January 15, 2025

RE: Thorndike Place, Dorothy Road, Arlington, Massachusetts – Preliminary Review of New Applicant Information

Attachment A:
MOUNDSOLV Summary Reports

2-Year, 24-Hour Storm Event

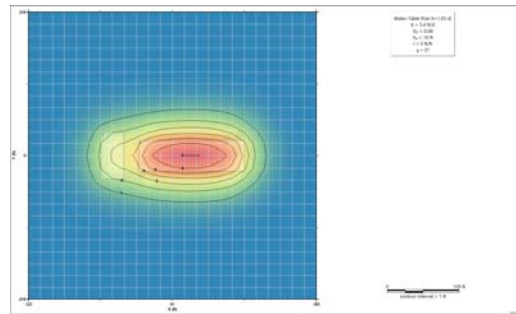
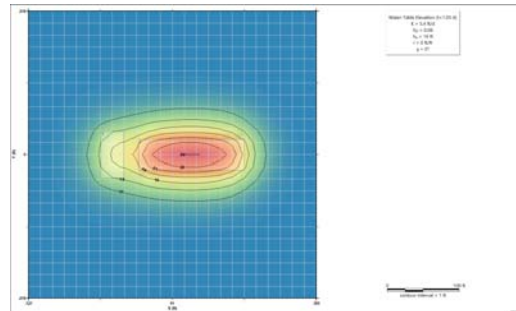
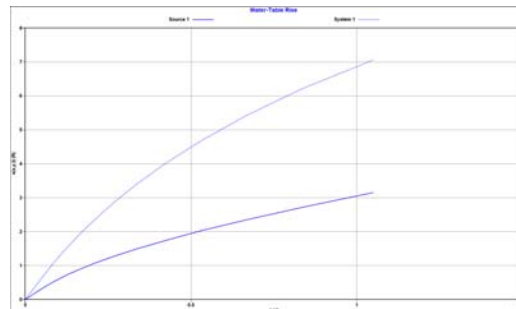
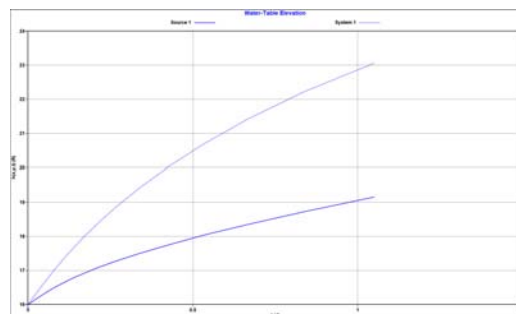
- Correcting only the two issues described above causes predicted groundwater mounding to rise well above the bottoms of Systems 1 and 7 during all considered design storm events, ranging from the 2-year, 24-hour storm event to the 100-year, 24-hour storm event (refer to **Attachment A**).
